UNITED STATES PATENT AND TRADEMARK OFFICE

10/748,535

| Office Action Summary | Application No. 10/748,535 | Applicant(s) WEVERKA ET AL. | |

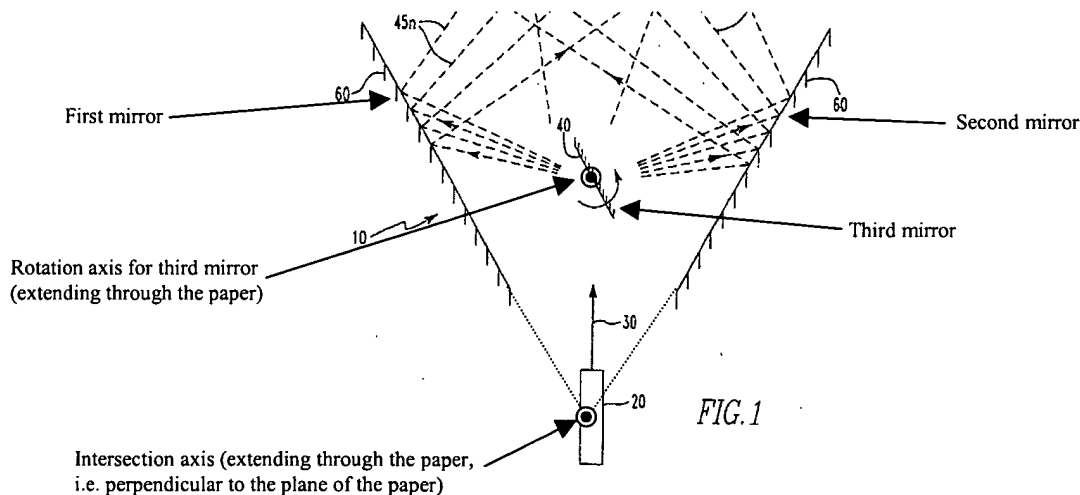
Claim 30 is rejected under 35 U.S.C. 102(b) as being anticipated by Welch (US 5,565,686).

Welch discloses an optical device with all the limitations set forth in the claims including: first and second flat mirrors, fixed at a particular included angle with respect to one another (figure above); said first and second flat mirrors defining an intersection axis (figure above); a third flat mirror mounted for rotation about a rotation axis parallel to the intersection axis (these axes are parallel as shown in the figure above); an actuator coupled to the third flat mirror configured to provide first and second angular positions about the rotation axis (column 4 lines 51-53); the first angular position being such to define an included angle of approximately 90 degrees between the first and third flat mirrors, the second angular position being such to define an included angle of approximately 90 degrees between the second and third flat mirrors (column 4 lines 51-53, column 4 lines 39-42). Since the third mirror rotates 360 degrees, first and second angular positions that define 90 degrees angle is inherently disclosed.

FIG. 4

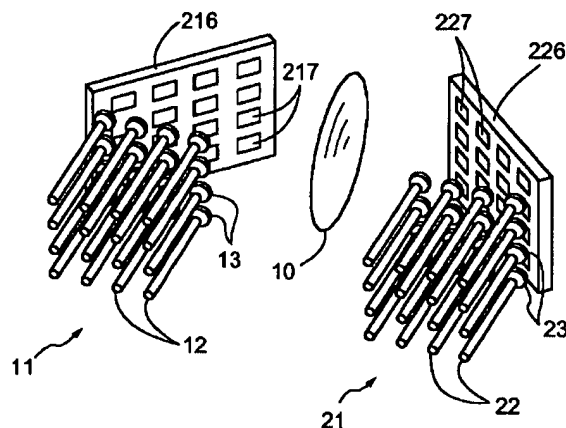
Claim 31 is rejected under 35 U.S.C. 102(e) as being anticipated by Kalman et al (US 6,424,756 B1)

Kalman discloses an optical device with all the limitations set forth in the claims including: a support element having first and second mounting surfaces lying in planes defining an angle therebetween of approximately 90 degrees ('216', '226' figure above); first and second MEMS micromirror arrays disposed on respective first and second substrates, mounted to the first and second mounting surfaces of the support element ('217', '227'; column 7 lines 29-30); a given micromirror in the first array being associated with a plurality of M micromirrors in the second array (column 7 lines 21-25); an actuator coupled to each given micromirror in the first array to provide M discrete orientations of the given micromirror, each orientation directing light along an incident direction toward different micromirror in the second array (column 7 lines 21-28); the plurality of M micromirrors in the second array having respective orientations such that each respective orientation is substantially 90 degrees to the orientation of the given mirror in the first array when the given mirror is oriented to direct light to that micromirror in the second array (see figure above). Since the input and output fibers ('12' and '22') are arranged in parallel, the orientation of the first mirror array is necessarily 90 degrees with respect to the orientation of the second mirror array in order to transmit light beam from the input fibers to the output fibers.
